MANDATORY SERVICE BULLETIN 09-560-01

SUBJECT: Improper Generator Wire Routing Causing Possible Electrical Fire

MODELS AFFECTED: All PA-46-310P/350P aircraft converted to the JetProp configuration in accordance with STC ST0541SE.

Figure 1. Improperly Routed Wire (Looking Down on the Accessory Gear Box Area)

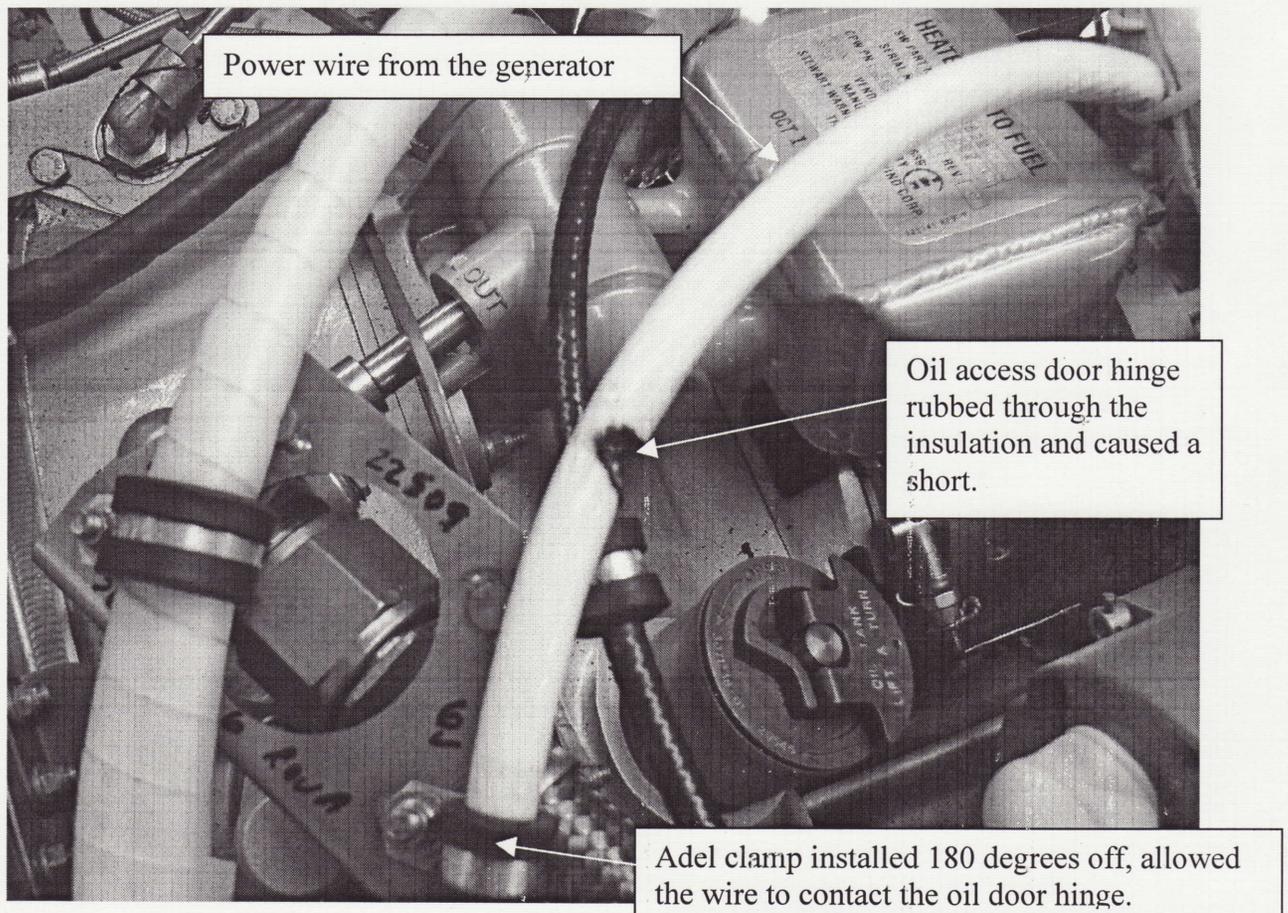
PROBLEM IDENTIFIED: It has been discovered that an improperly routed primary power wire from the generator could contact the oil access door hinge and over time wear through the insulation causing an electrical short and potential electrical fire (Figure 1).

- (2) **At the next maintenance event.** Remove the top cowling and inspect the electrical wiring from the generator to the firewall for security and chafing. If any chafing has occurred, correct the problem and replace and secure the wire as necessary. Special emphasis should be placed on the security of the wires around the oil access door hinge when the door is closed. The wires must be secure and there should be at least 1 inch of clearance between the wires and the door hinge when the door is closed. The adel clamp (on the 560.07.706 Cable Bracket attached to the oil line on the top of the engine) holding the primary power wire from the generator should be oriented as shown in Figure 3 to give the needed spacing between the wire and the oil door hinge. If the adel clamp is orientated improperly as shown in Figure 1, correct the

installation and change the orientation of the adel clamp to that shown in Figure 3. If the wire is too short after changing the adel clamp orientation, replace the wire. Please email JetProp if you find the adel clamp was installed improperly or any other problems are identified. Some of the early aircraft may not have exactly the same wire routing. However, the clearance requirements and wire security are still the same.

Figure 2. Oil Door Access

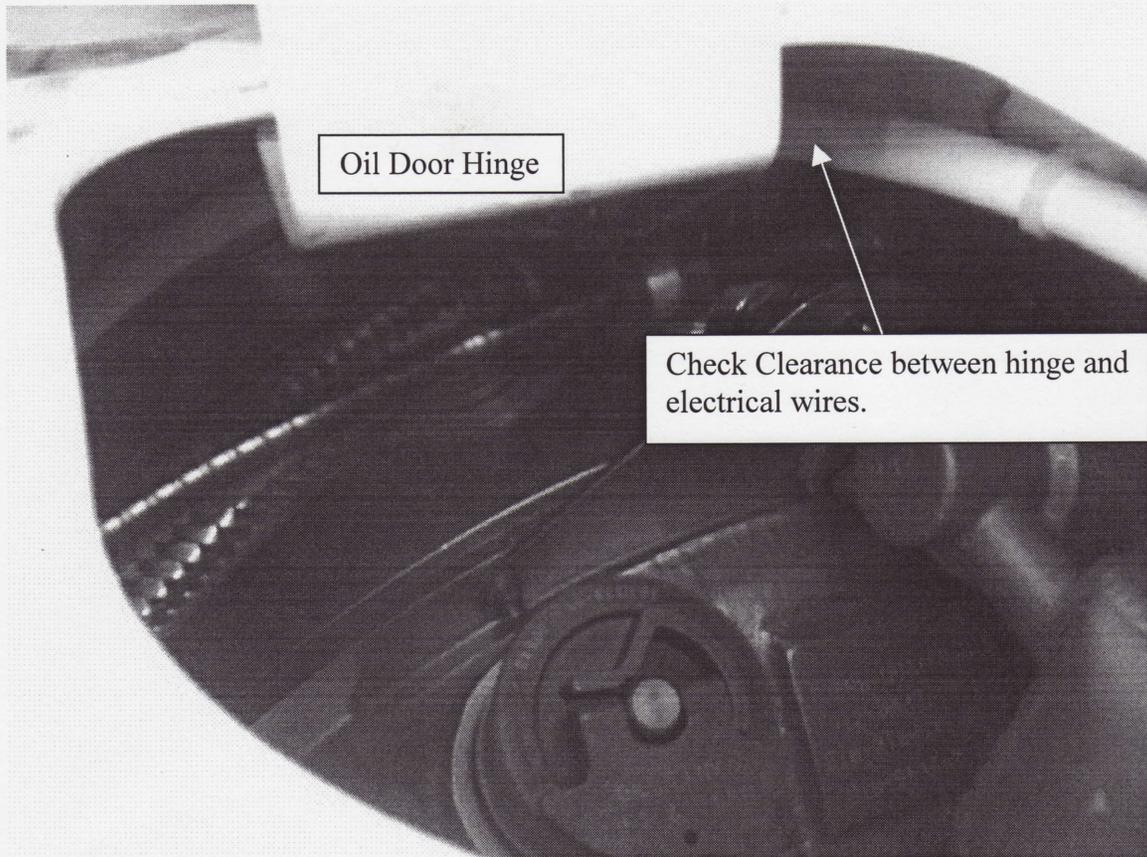
- (1) **Prior to the next flight.** Open the oil access door (See Figure 3) and look inside to ensure there is at least 1 inch of clearance between the electrical wires and the oil door hinge when the door is closed. If there is less than 1 inch of clearance, proceed as in item (2) below. *As soon as this has been completed, please send a reply email to Rich@JetProp.com and let us know the results of this inspection. THIS IS A MUST!!!*
